City of Portland
Bureau of Development Services
Land Use Services Division

NOTICE OF A TYPE II DECISION ON A PROPOSAL IN YOUR NEIGHBORHOOD

CASE FILE NUMBER: LU 08-115939 AD

The applicant is proposing to construct a two-story, approximately 790 square foot Accessory Dwelling Unit (ADU), in the northwest portion of the site, in the approximate location of the existing detached garage (which will be demolished).

Exhibit C-1

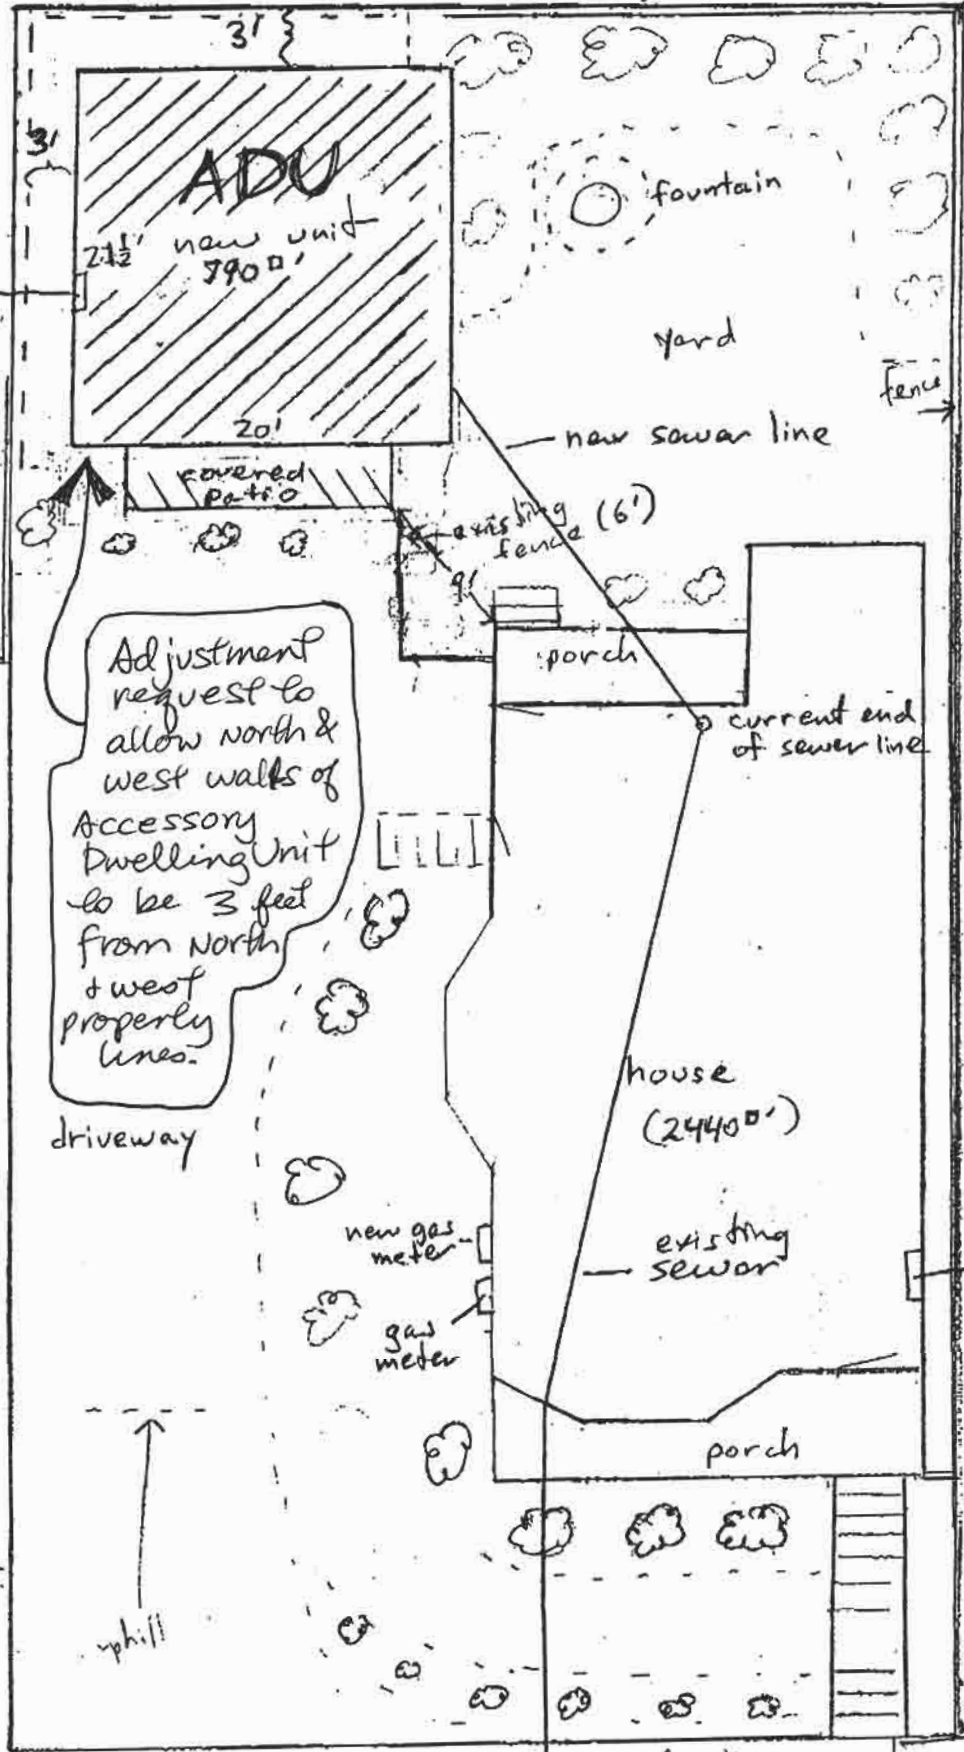
- As indicated on the applicant's site plan, the south wall of the ADU will be no further south than the south wall of the garage it is replacing. Therefore, the ADU's location will remain to the north of, and behind, the house on the abutting property to the west.

- The north and west walls of the ADU will be 2 feet further from the north and west property lines, than the north and west walls of the garage. Therefore, the ADU will have an increased separation distance from the abutting houses to the west and north, compared with the garage it is replacing.

Adjustment request to allow north & west walls of Accessory Dwelling Unit to be 3 feet from north & west property lines.

A setback adjustment to Section 33.120.220 and Tables 120-3 and 120-4, to allow the north wall of the proposed ADU to have a minimum setback of 3 feet from the north property line, with the north eave of the ADU to have a minimum setback of 2 feet from the north property line, and;

A setback adjustment to Section 33.120.220 and Tables 120-3 and 120-4, to allow the west wall of the proposed ADU to have a minimum setback of 3 feet from the west property line, with the west eave of the ADU to have a minimum setback of 2 feet from the west property line;

- B. A 6-foot site-obscuring fence must be constructed along the portion of the west property line that is parallel with the length of the west wall of the ADU, and along the portion of the north property line that is parallel with the length of the north wall of the ADU.

Exhibit C-2

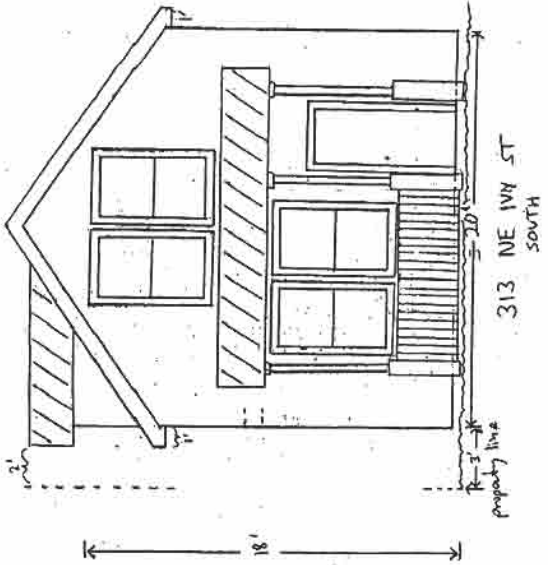
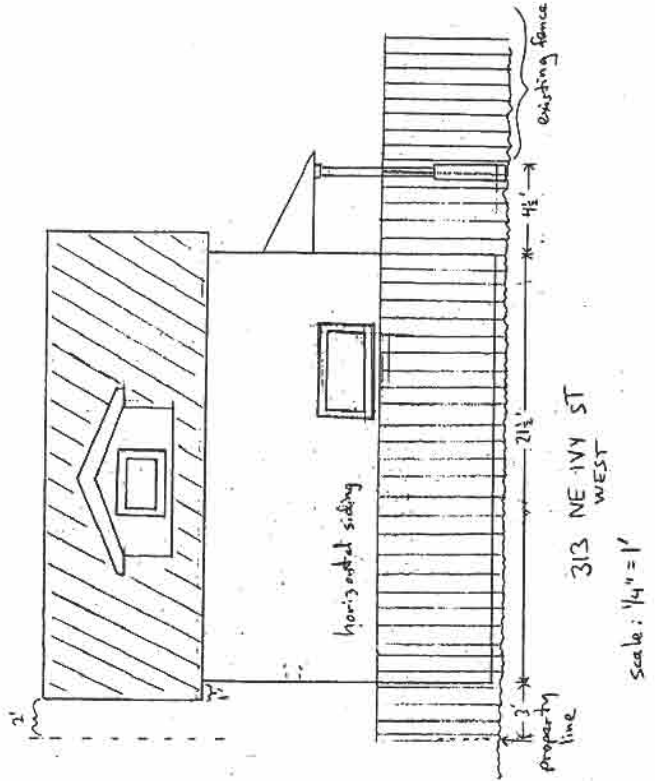
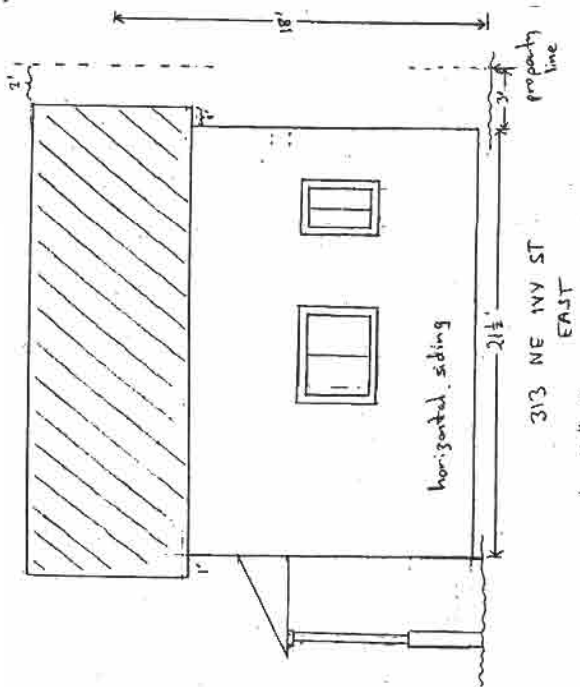
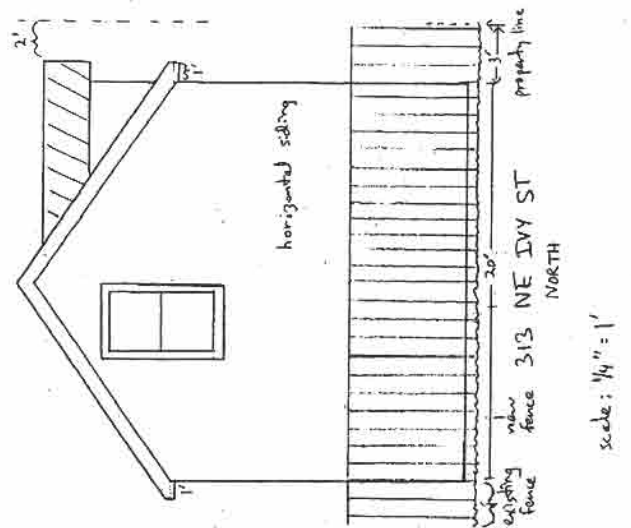
- A new 6-foot solid fence is proposed along the site's north and west property lines, between the ADU and the abutting properties to the north and west. The fence will screen the lower portion of the ADU from view, and will maintain privacy between the first floor of the ADU and the abutting properties.
- The windows on the ADU's west wall will be set at 6 feet above the finished floor to allow light into the ADU while limiting views from the ADU into neighbors' yards.
- The window area on the north wall of the ADU will be limited to one window on the second floor level, which will be approximately 4 feet wide by 6 feet tall (24 square feet in area).

Staff concurs that the proposed fence, the high window placement on the west wall, and the limited window area on the north wall, will promote privacy. The north wall of the ADU will have a significant separation distance of at least 50 feet from the existing single-dwelling residences in the abutting properties to the north, thus promoting privacy for those dwellings. The multi-dwelling zoning of the abutting properties to the north allows for future redevelopment of each property with up to two residential units, and new residential units could possibly have a separation distance of less than 50 feet from the north wall of the ADU. However, the proposed ADU's one north-facing window at 3 feet from the property line represents minimal privacy impact to future multi-dwelling development on the abutting property to the north, when compared to an ADU at the required 5 feet from the property line that would be allowed to have multiple windows on its north façade.

- C. The windows on the west wall of the ADU must have a sill height that is at least 6 feet above the finished floor.
- D. The window area of the north wall of the ADU is limited to one window with a maximum area of approximately 24 square feet.
